Subject: **Addendum to Soil and Water Delineation Work Plan**
1532 Peralta Street, Oakland, California

**ADDENDUM
TO
SOIL & WATER DELINEATION WORK PLAN**

**Fuel Leak Case RO0000117
1532 Peralta Street, Oakland, California 94607**

GGTR Project No. 8757
March 20, 2007

PROPOSED INVESTIGATION ACTIVITIES
1532 Peralta Street, Oakland, California

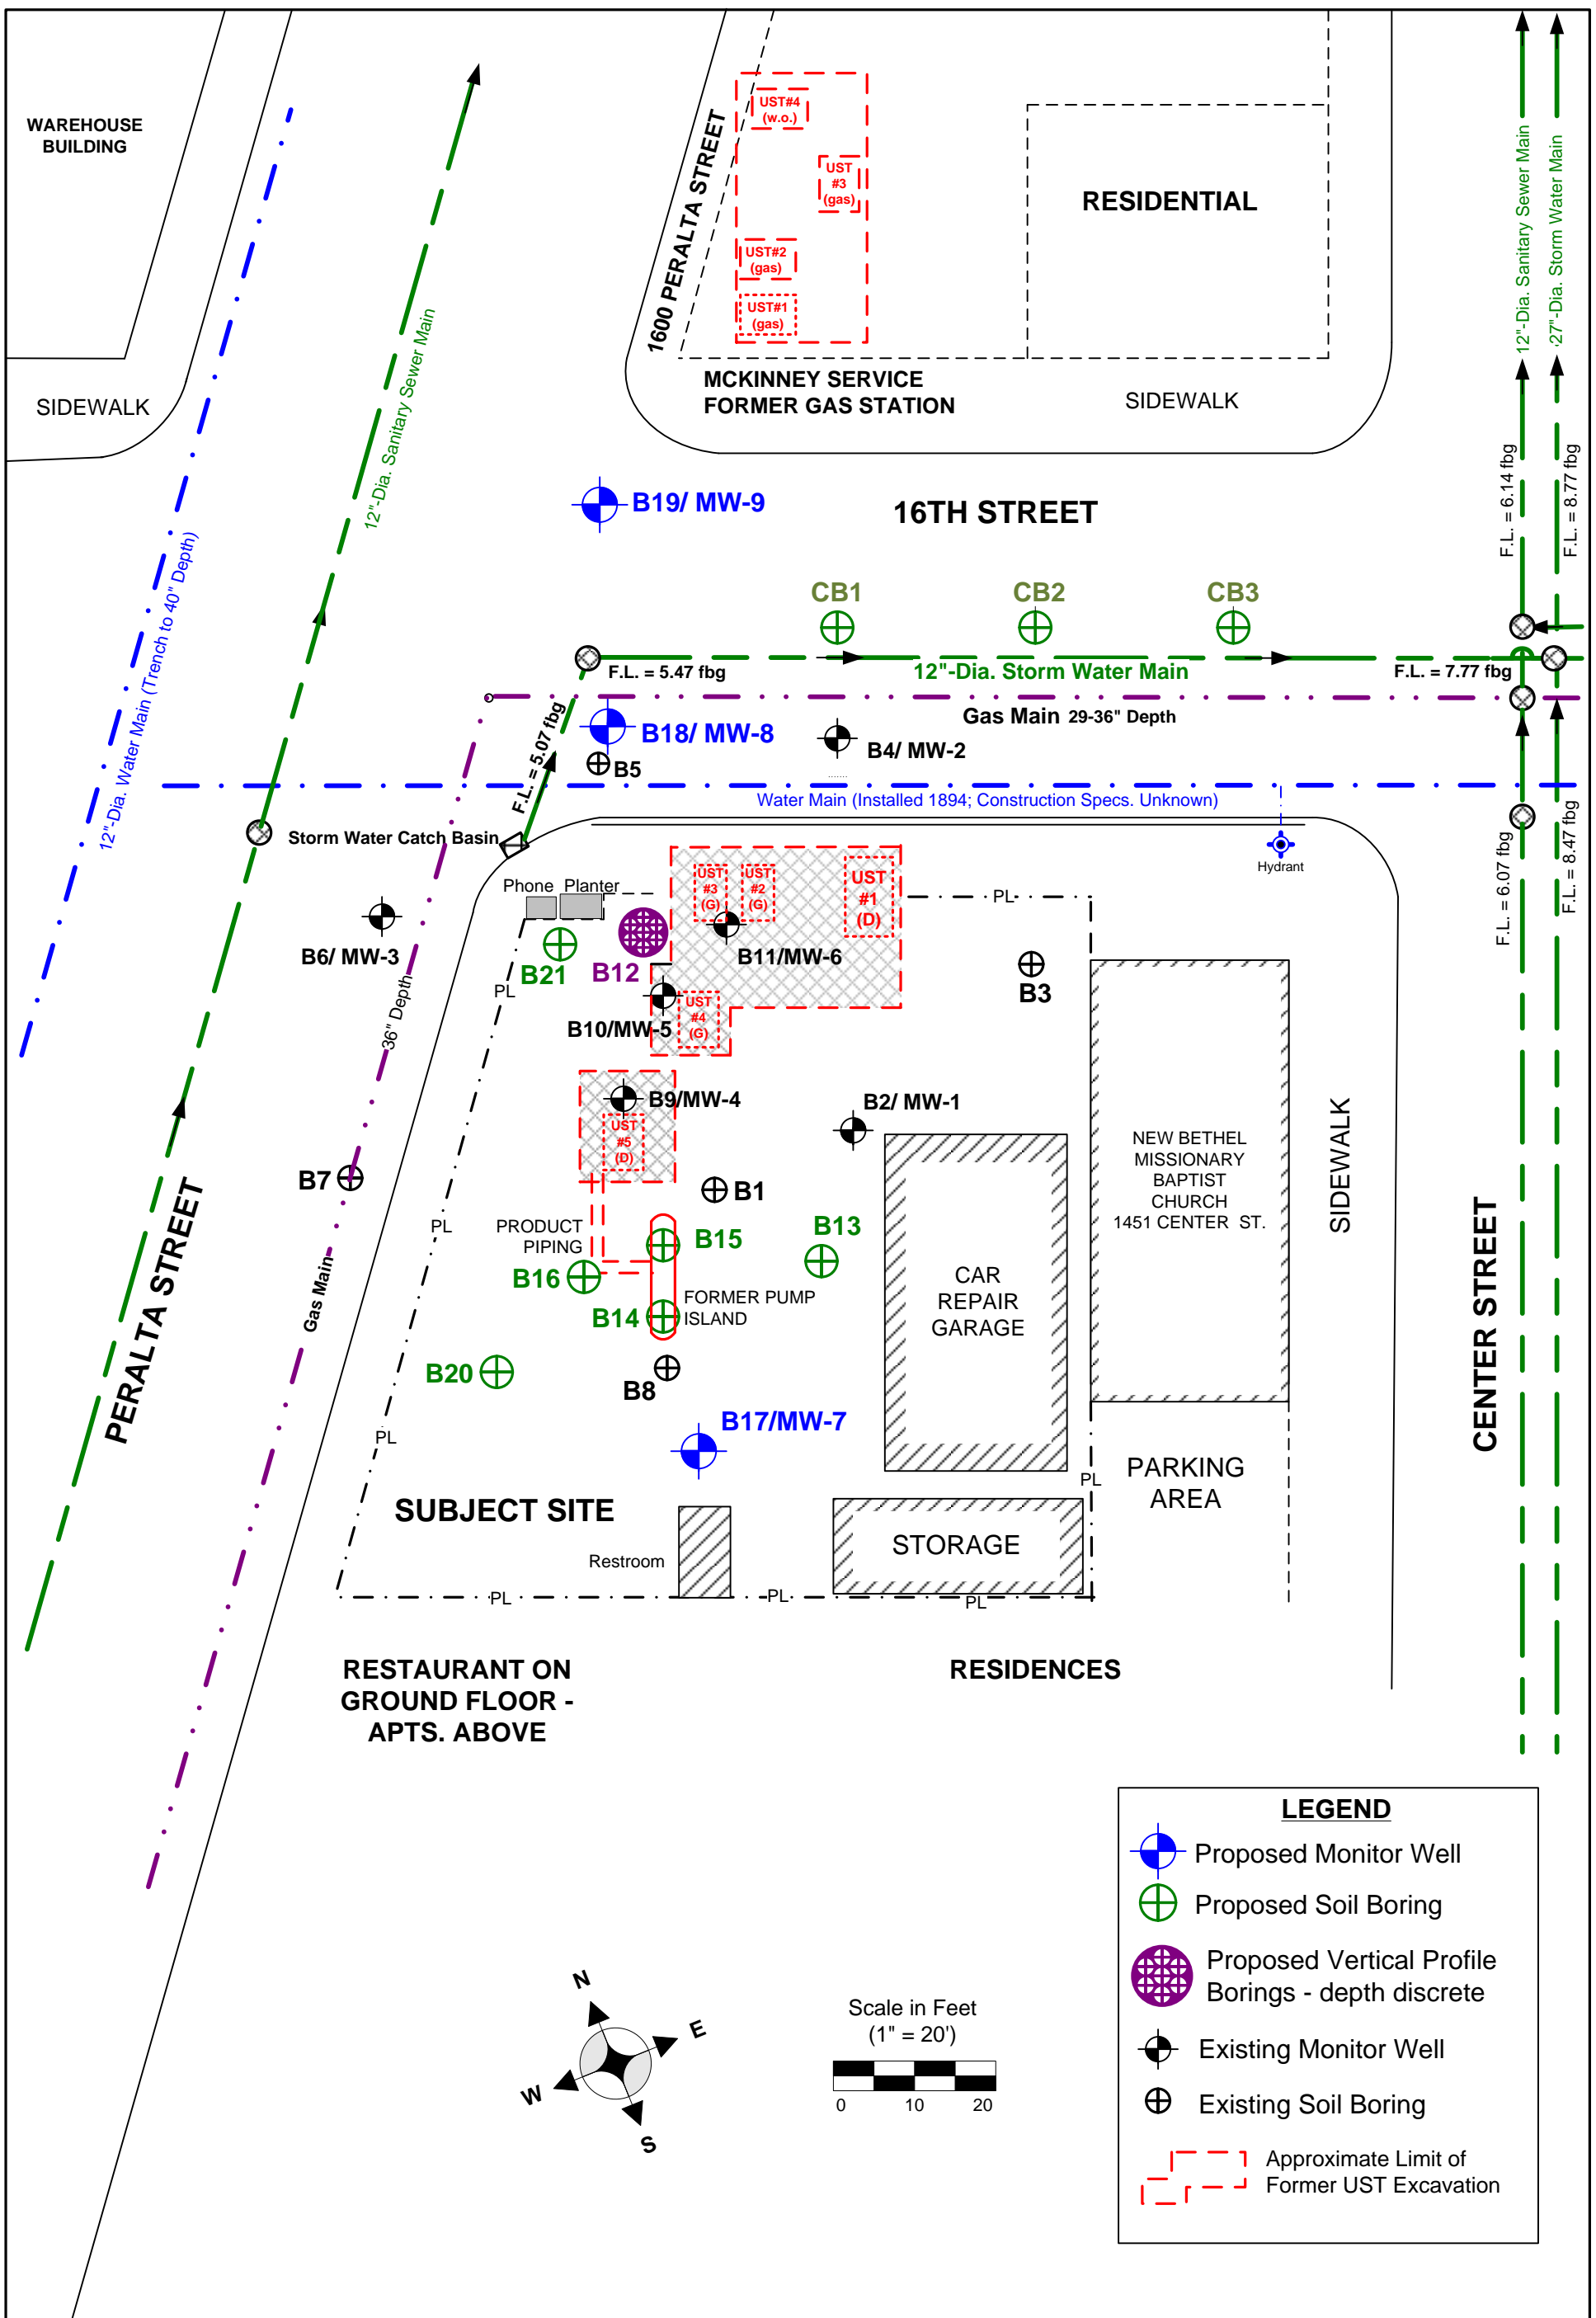
GGTR proposes to drill three shallow Geoprobe borings, CB1-CB3, along the suspect storm water main in 16th Street as shown on the attached Figure 1 – Proposed Investigation Activities. The last groundwater monitoring event in December 2006 did not detect significant contamination in well MW-2 up-gradient of the storm water main. Groundwater in this area of the site has been measured to vary seasonally from about 1.7 to 3.6 feet bsg. The invert of the 12-inch diameter storm water main varies from a depth of 5.07 feet bsg at the curb catch basin to 5.47 feet bsg in the manhole at the intersection of Peralta & 16th Streets. The storm water main then flows eastward to a manhole at the intersection of Center & 16th Streets with an invert depth of 7.77 feet bsg. Within this intersection, the 12-inch main reportedly joins the 27-inch storm water main along Center Street with an invert depth of 8.47 feet bsg. We estimate the invert of the storm water main will decrease from about 6 feet to about 6 ½ feet below surface grade (bsg) in the area of the proposed soil borings. A gas main at a depth of 29-36 inches bsg is also a possible pathway in 16th Street. The last groundwater monitoring event in December 2006 did not detect significant contamination in well MW-2 down-gradient of the gas main. The proposed boring locations were spaced 25 feet apart starting down-gradient of well MW-2. We estimate that the north or down-gradient side of the storm water main has the highest likelihood of encountering potential contamination originating from inside the storm water main and/or adjacent gas main.

GGTR proposes to perform vertical profile characterization near the former UST locations. ACEH has requested the location of boring B12 be repositioned approximately 15 feet to the north. GGTR agrees to re-locate boring B12 as shown on the attached Figure 1- Proposed Investigation Activities.

scope of work for the drilling and sampling according to comments in the ACEH letter. GGTR has re-numbered the proposed borings to reflect these changes as shown on Figure 1 - Proposed Investigation Activities. One boring B13, now a Geoprobe boring, will recover soil samples from target depths of 3, 6, 10 and 15 feet bsg or zones of obvious contamination for laboratory analysis of petroleum constituents. If significant field screening evidence of petroleum contamination is encountered at 15 feet than additional soil samples at intervals of approximately five feet (soil intervals of obvious contamination will be targeted in the sampling) will be added until the vertical extent of obvious petroleum contamination is determined.

In their letter, ACEH approved the installation of three additional groundwater monitoring wells in the locations shown on Figure 1 - Proposed Investigation Activities. As requested, GGTR is proposing to design the construction of these wells according to data obtained from prior vertical contamination characterization in deep Geoprobe boring B12. GGTR will provide ACEH updated diagrams of the proposed well constructions, if modified, prior to the installation of the proposed wells.

Figure 17

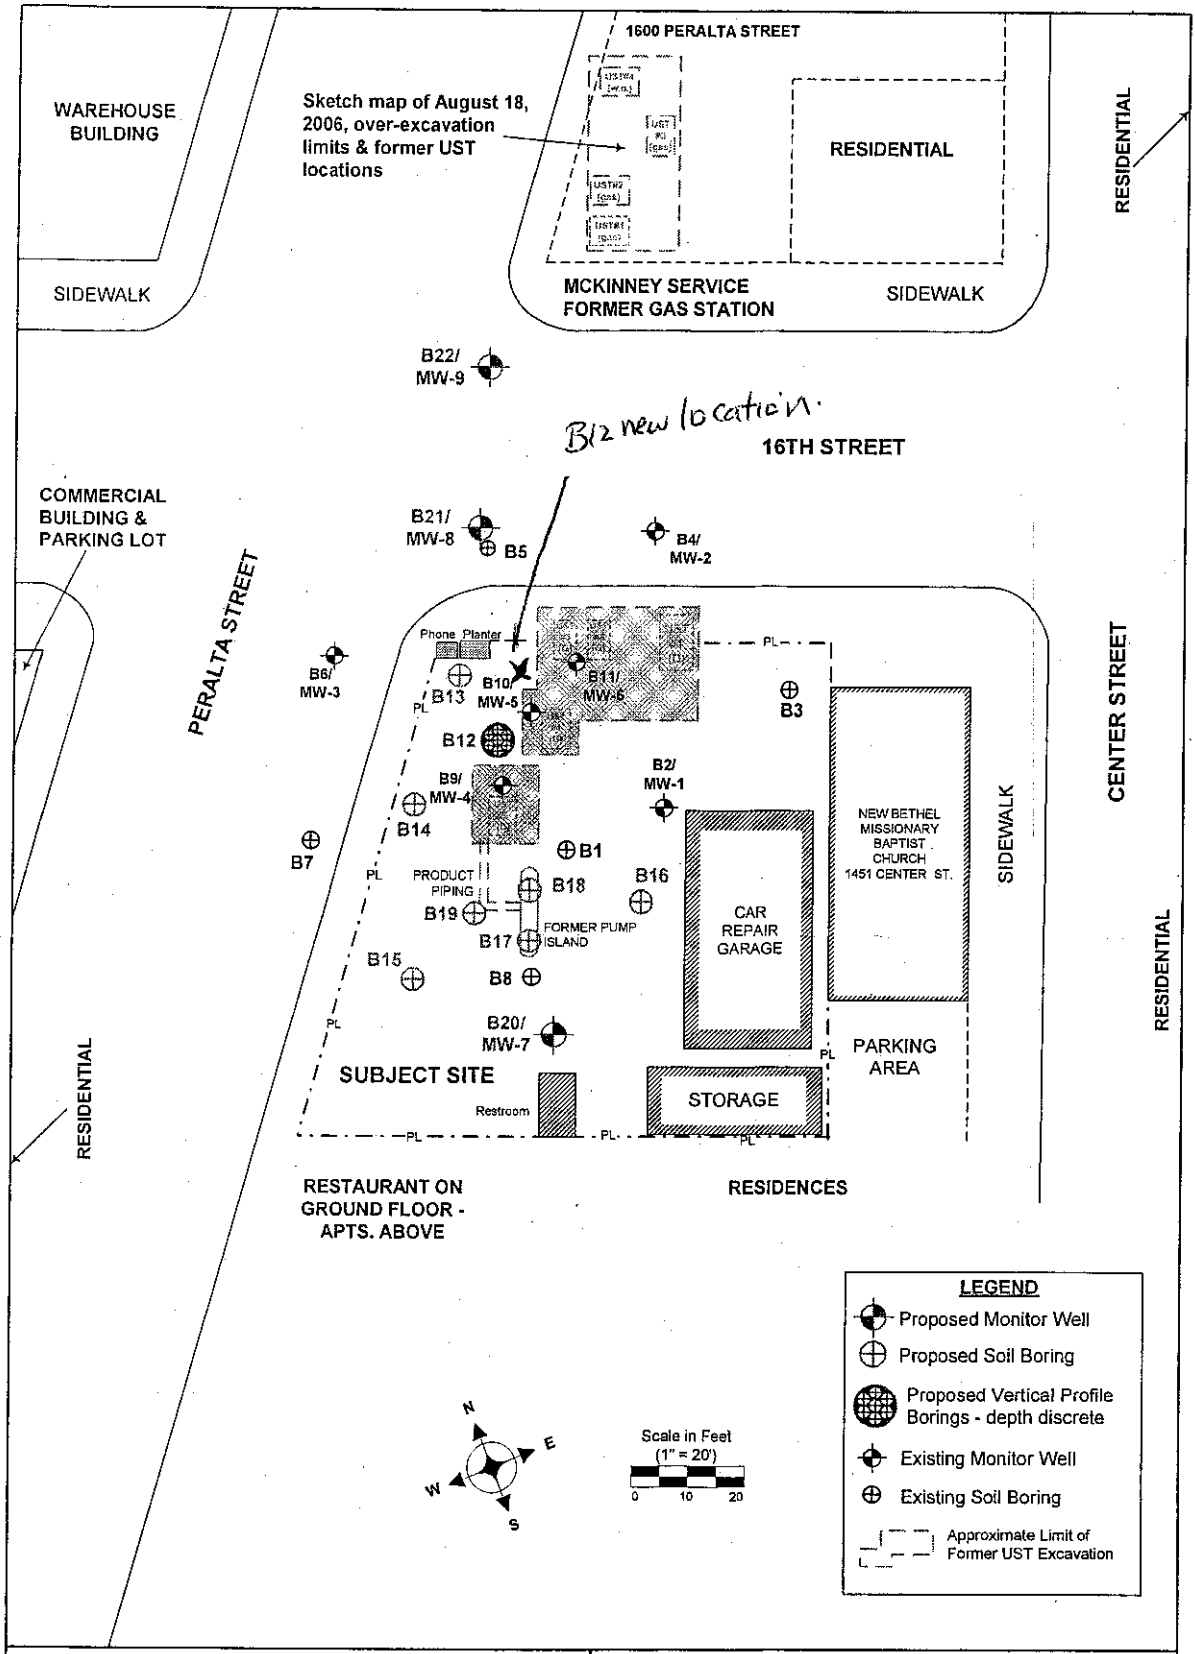
- The vertical profiling of groundwater contamination is proposed for characterization by drilling a deep Geoprobe boring, B12, to 40' bgs. The lithology will be continuously logged and soil samples collected every five feet, at zones of apparent water bearing capacity and obvious areas of contamination. Using this data, additional clustered hydropunch borings and depth discrete water samples collected from the zones of interest. We approve this proposal with the condition that B12 be moved to be located down-gradient of MW-5. See the attached figure for the recommended location.
